Comment

(TDL #162 from D2.1)

1. Some updates are required for D2.2 for moving some of the normative requirements in Annex B to the standard body into 33.2.8.5.1 as requested by TDL #162.
2. As a result from (1), Annex 33B was updated accordingly and became informative

33.2.8.5.1 PSE PI pair-to-pair effective resistance and current unbalance

Figure 33B-1—PSE PI unbalance specification and E2EP2PUnb

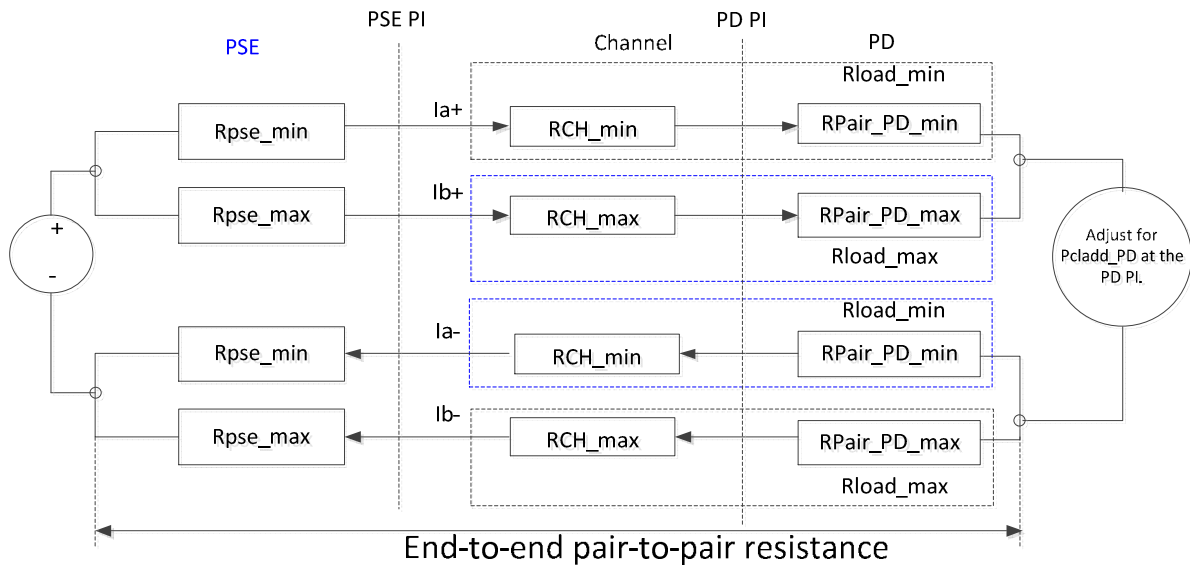
**Move Figure 33B-1 to 33.2.8.5.1 (to this location) with the marked updates.
Update Figure numbers as required.**

R_{Ch} is the maximum value of (RCH_min + RCH_max) as described in Figure 33-B1.

RCH_max is the sum of channel pair elements with highest common mode resistance and RCH_min is the sum of channel pair elements with lowest common mode resistance.

Figure 33B-4—Current unbalance test circuit

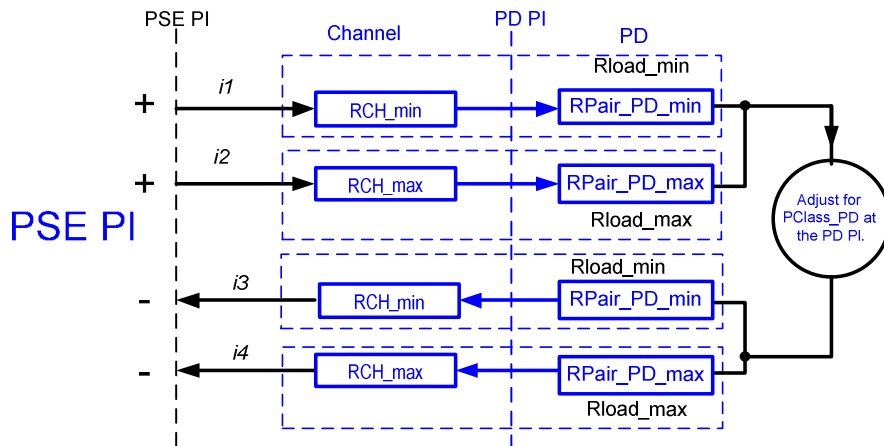
Move Figure 33B-4 to this location with the following marked updates.

The current unbalance test circuit is shown in Figure 33B-4. The test method is described below:

- 1) Use Rload_min and Rload_max from Table 33B-1 for Rload at low channel resistance conditions.
- 2) With the PSE powered on, adjust the load to Pclass_PD.
- 3) Measure I1, I2, I3 and I4.

4) Swap Rload_max, Rload_min, repeat steps 1 and 2.

5) Repeat for I3, I4.

6) Verify that the current in any pair each case does not exceed Icon-2P_unb minimum in Table 33-18.

7) Repeat steps 1-6 for Rload_min and Rload_max from Table 33B-1 for Rload at high channel resistance conditions.

Figure 33–39—Icon-2P and Icon-2P-unb evaluation model

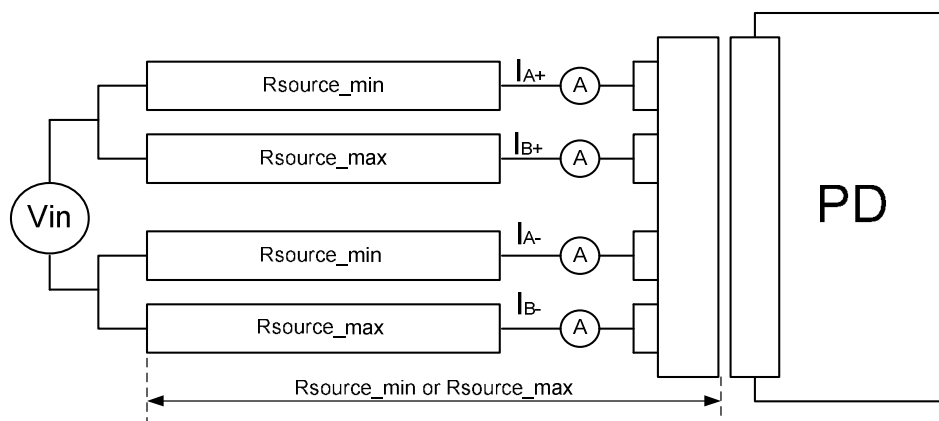
-In previous drafts we have used average ratio of $R_{\text{source_max}}/R_{\text{source_min}}=1.186$ for both short cable case and long cable case. The following changes were made after founding that using constant ratio between $R_{\text{source_max}}$ and $R_{\text{source_min}}$ is not sufficient due to 15% differences between the ratio required for the short cable and the ratio required for the long cable.

Under all operating states, single-signature PDs assigned to Class 5 or higher shall not exceed ICon-2P- unb for longer than TCUT-2P min as defined in Table 33–18 on any pair when PD PI pairs of the same polarity are connected to all possible common source voltages in the range of VPort_PSE-2P through two common mode resistances, $R_{\text{source_min}}$ and $R_{\text{source_max}}$, where ~~$R_{\text{source_max}} = 1.186 * R_{\text{source_min}}$~~ $R_{\text{source_max}} = (-0.031 * R_{\text{source_min}} + 1.309) * R_{\text{source_min}}$, and $R_{\text{source_min}}$ are all possible resistances in the range of ~~$0.1680.147 \Omega$~~ to ~~$5.28-5.568 \Omega$~~ as shown in Figure 33–37.

Figure 33A-XX – Common mode Pair-to-pair channel resistance unbalance

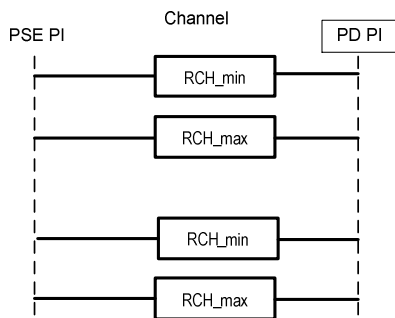
Not part of the baseline
 Figure 33A-XX was added to differentiate between R_{ch} term used from PSE PI to PD PI and back and the channel resistance of pair of wires and their connectors from PSE PI to PD PI (one way) that is used in this Annex and all related P2Punb clauses.

Add Figure 33A-XX

Figure 33A-4—PD resistance unbalance elements overview

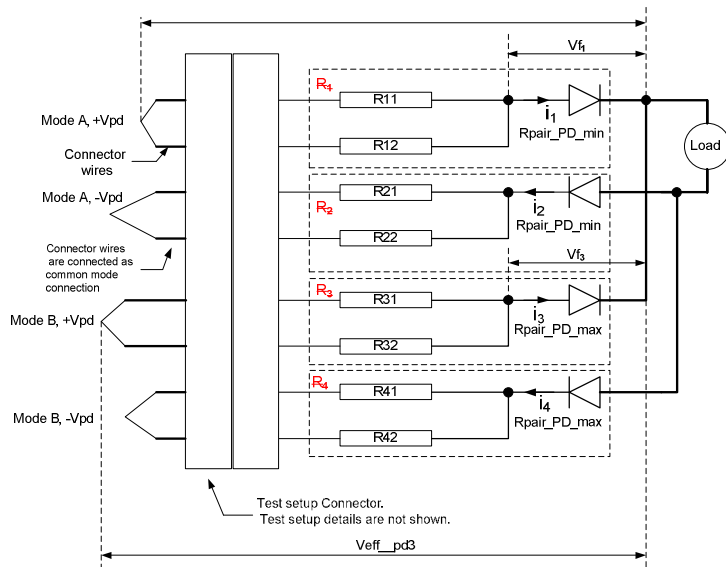
We can simplify text and drawing by deleting R1, R2, R3 and R4 from the text and Figure 33A-4 since we have we have Rpair_PD_min/max definitions already in the drawing and the text.

Figure 33B-1—PSE PI unbalance specification and E2EP2PRunb

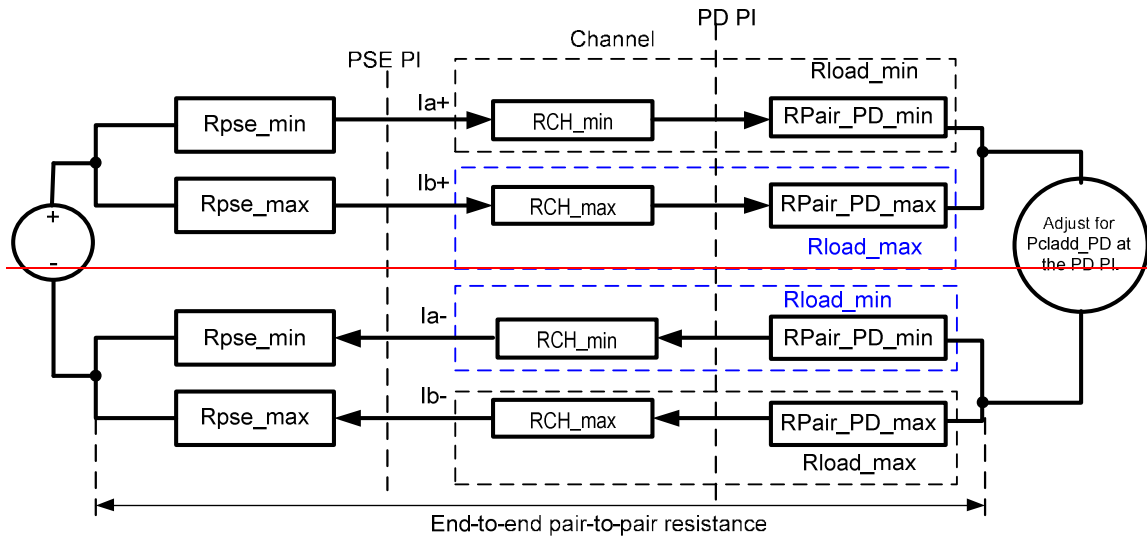
Delete Figure 33B-1. It was moved and updated to 33.2.8.5.1

Figure 33B-3 – Effective resistance test circuit

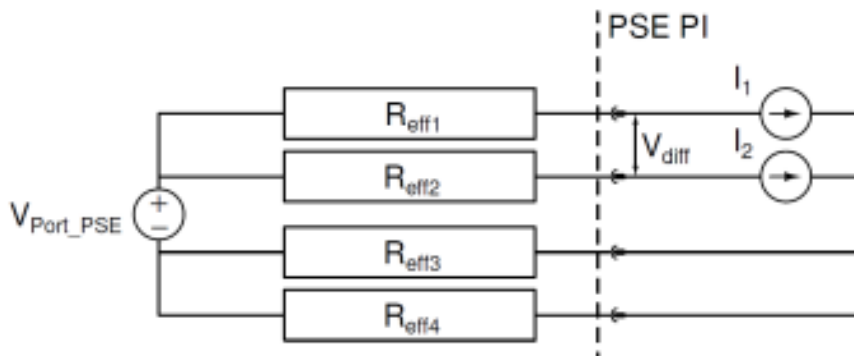
Add to TDL: Ken to verify that the following test model works in simulations

Figure 33B-3 shows a possible test circuit for effective resistance measurements on a PSE port for evaluating conformance to Equation (33-15) if the internal circuits are not accessible. In Figure 33B-3, the positive pairs of the same polarity are shown as an example. The same concept applies to the negative pairs.
